STAFF REPORT  
ST. VINCENT DE PAUL SOCIETY OF LANE COUNTY  
DRIVE-UP DONATION  
CONDITIONAL USE PERMIT CUP 3-22  
DECEMBER 21, 2022

Location: 910 Row River Road  
20-03-27-31 00210 & 00211

Proposed Condition: 19,000 sf retail development with drive-up donation facility and sorting facility (coffee stand at 185 Thornton to remain)

Figure 14.23.180.A(1) Drive-Up and Drive-Through Facilities

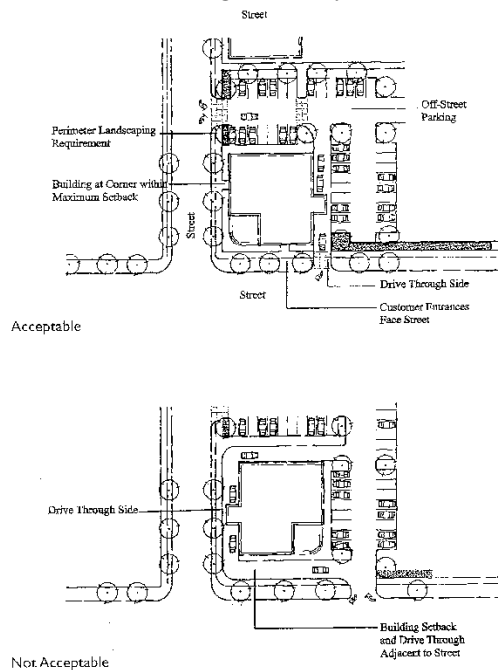
Per Section 14.23.180, the siting of the proposed drive-up shall not be placed between the main building entrance and the right-of-way as shown in the graphic below.

The applicant has proposed the location of the drive-up facility to be located at the north end of the proposed building with the drive aisle isolated from the parking areas and parking area drive aisles and maneuvering areas. Additionally, the location of the proposed drive-up is such that a direct pedestrian connection to the right-of-way is maintained and the drive-up facility drive aisle does not need to be crossed for pedestrians to access the building. There is one delineated pedestrian crossing of the drive-up aisle that connects the parking area to the north to the main entry plaza for the building. As proposed staff recommends approval of the proposed configuration of the drive-up facility.
